Operational Readiness Clearance (Non-beam operation)

E906 SeaQuest MagneSt

AUTHORIZATION TO PROCEED WITH THE UNATTENDED OPERATION OF KTeV ANALYSIS AND SWEEPER MAGNETS FOR E906 (SeaQuest)

FERMI NATIONAL ACCELERATOR LABORATORY UNITED STATES DEPARTMENT OF ENERGY	
PARTICLE PHYSICS DIVISION NM BEAM NM3 & NM4	
OPERATOR BEVERLY CUNY	DRAWING NUMBER 2231-EB-173223 SH. 27
	REV. C

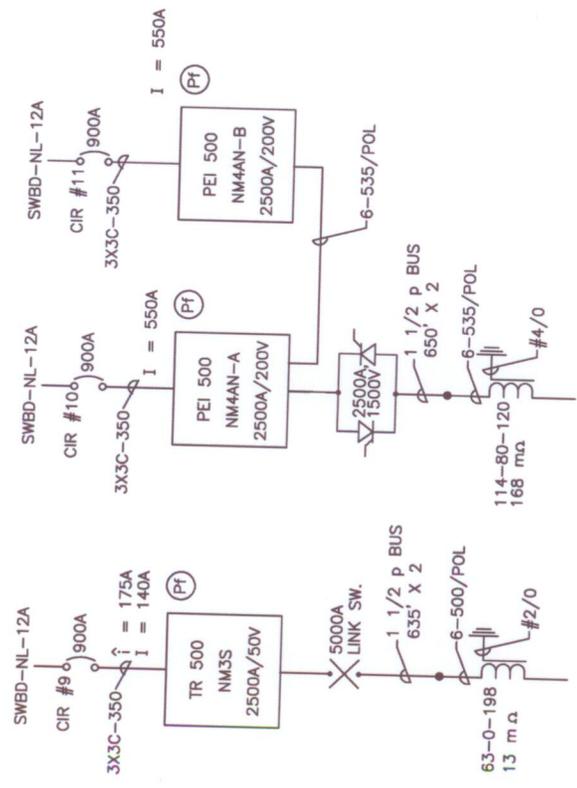
Now another item as I dust off my files is that we never closed the loop on Fmag. One part of that is that we wanted an updated version of drawing 2231-EB-173223 SH. 27; Keith said he'd get it made but he hadn't. I'll ping him again and cc: you. The other part of it is that I spoke with Dan Johnson, (d_johnson@fnal.gov, 840-2074) back some time ago now and he asked the following questions:

DESCRIPTION	REV.	DATE
A ORIGINAL		3/26/93
B REVISED		12/17/95
C Revised/Calculations for Cir. #19	PML	5/23/2011
